Application Reference: 145463/NMC/2026

Plot H5, land at Chicago Avenue to the north of the Voyager office building and south of the Tribe hotel, Manchester Airport M90 3RA
Application for a Non-Material Amendment to Planning Permission 141662/FO/2024

Fig.1

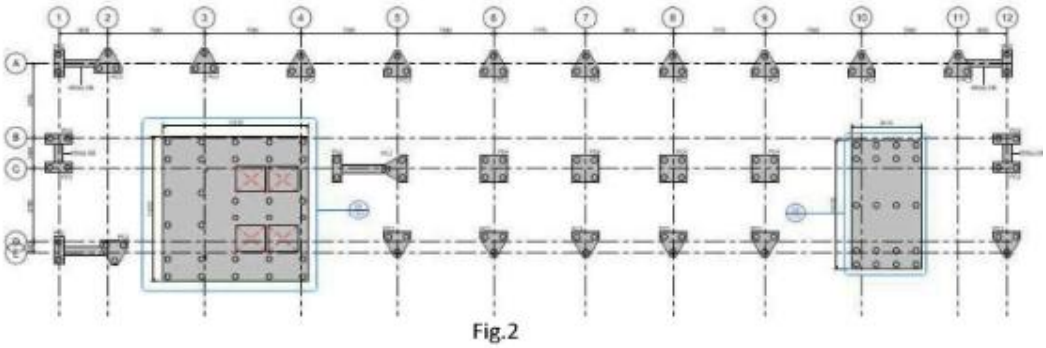
Separately, we have provided an updated Metrolink Limit of Deviation Plan (H5PI-5PA-00-00-DR-A-021200 Rev P02) for information only. Whilst the amended plant enclosure extends approximately 0.9m closer to the Limit of Deviation (LOD) at its nearest point, making the corner of the plant enclosure 9.5m away from the LOD, the building's sub-surface foundations remain in their originally approved positions (around the perimeter of the nine-storey building).

The sub-structure foundations will be no closer to the LOD than previously consented and remain consistent with the approved Construction Management Plan (extract from page 14 reproduced below).
